AF-Church Ave., Cliff Island
Assessors No. 1098-P-48

Permit to construct a 1-story frame addition
17'x17' on left hand side of dwelling and to replace 15 foot
portion of sonotube house foundation with 10 inch concrete
wall is being issued subject to compliance with the following
conditions:

APPLICATION FOR PERMIT

To construct 1-story frame addition 17' x 17' on left hand side of dwelling.

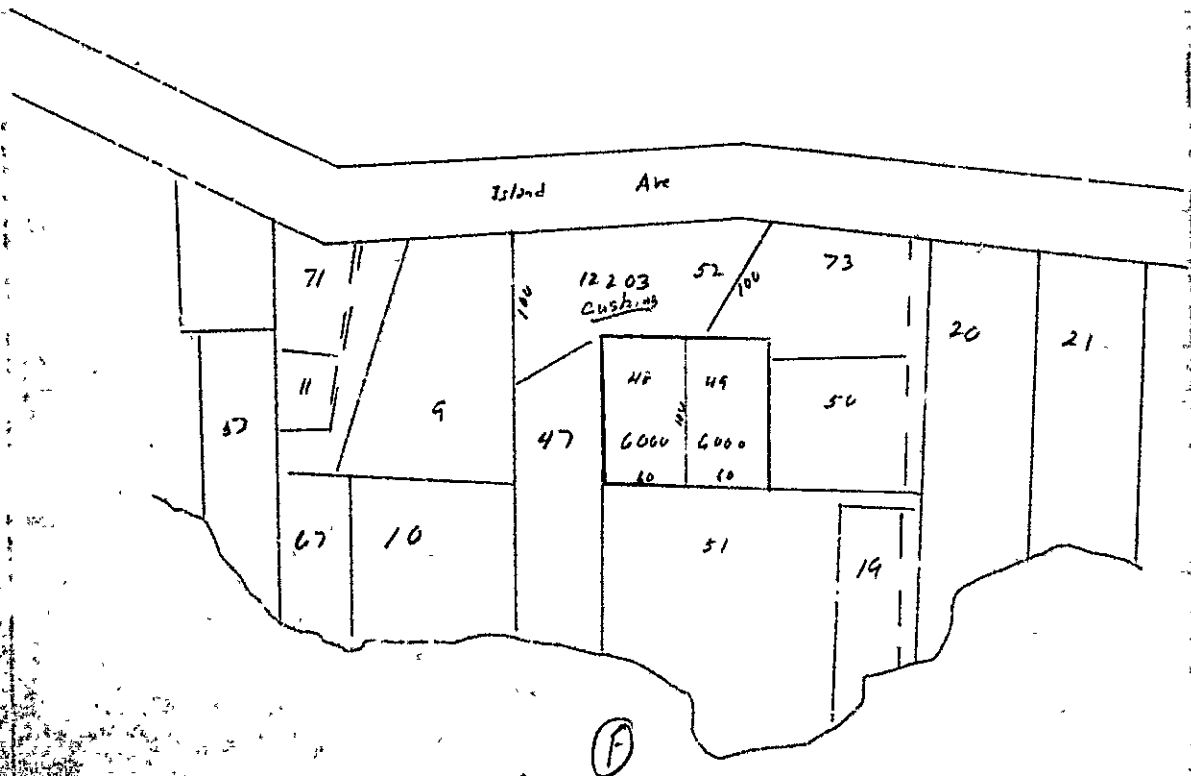
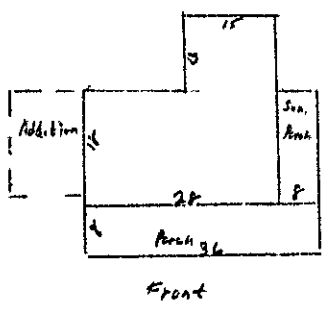
1. Girder supporting addition floor will need to be a 6x8 inch member set on edge rather than the 6x6 inch member shown. If this member is spliced, then it will need to have an 8 inch lap splice directly over the 10 inch diameter center pier.
2. Concrete piers for porch will need to be 9 inch diameter if round or if square 8 inches.
3. The 2x6 inch joists for porch floor may rest on top of the 4x6 inch sills or if flush framed to the 4x6 inch sills then they are to be notched over a 2x3 inch nailing strip securely spiked or bolted to the lower portion of the 4x6 inch sills.

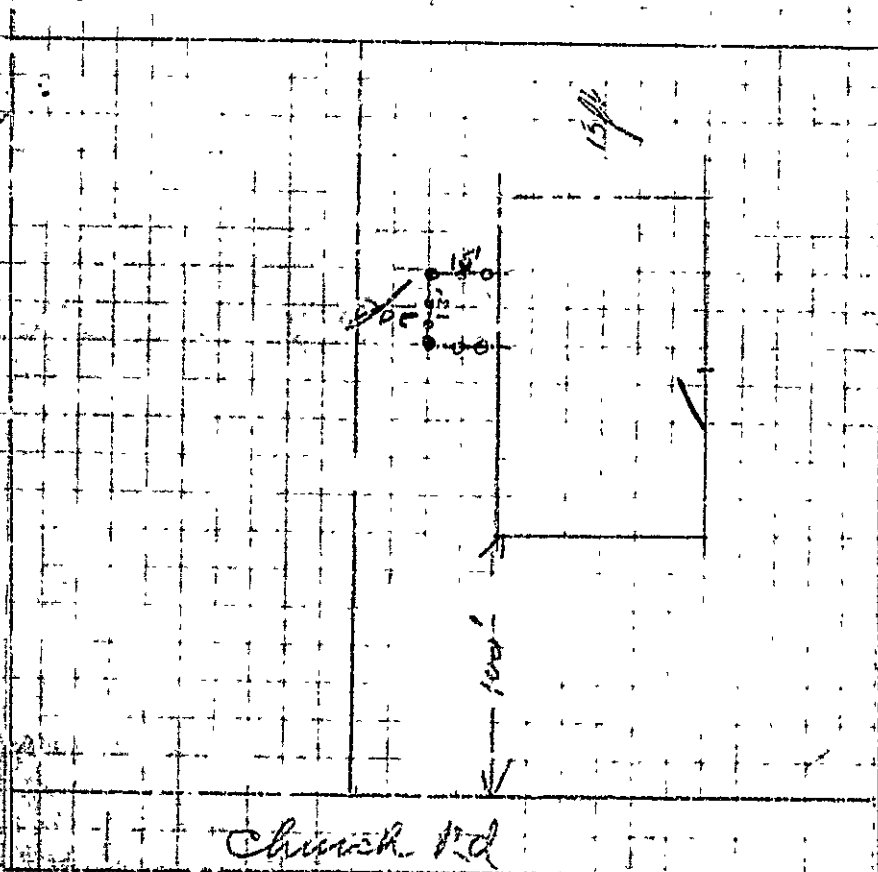
- how many piers are to be provided for support of the 4x5 girder beneath center of floor timbers? Is this girder to be laid flat or set on edge with the six inch dimension upright?
- the 2x6 rafters on a 15 foot span indicated for the shed roof are not adequate. On this span 2x6 rafters spaced 12 inches on centers or 2x10's spaced not over 18 inches on centers are required. Which will you use?
- with what material is the outside of the walls of the addition to be covered.

- how many pieces are to be provided for support of the 4x6 girder beneath center of floor joists? Is this girder to be laid flat or set on edge with the six inch dimension upright? *3 pieces*
- the 2x6 rafters on a 15 foot span indicated for the shed roof are not adequate. On this span 2x8 rafters spaced 12 inches on centers or 2x10's spaced not over 18 inches on centers are required. Which will you use? *2x8 rafters*
- with what material is the outside of the walls of the addition to be covered. *asbestos siding*
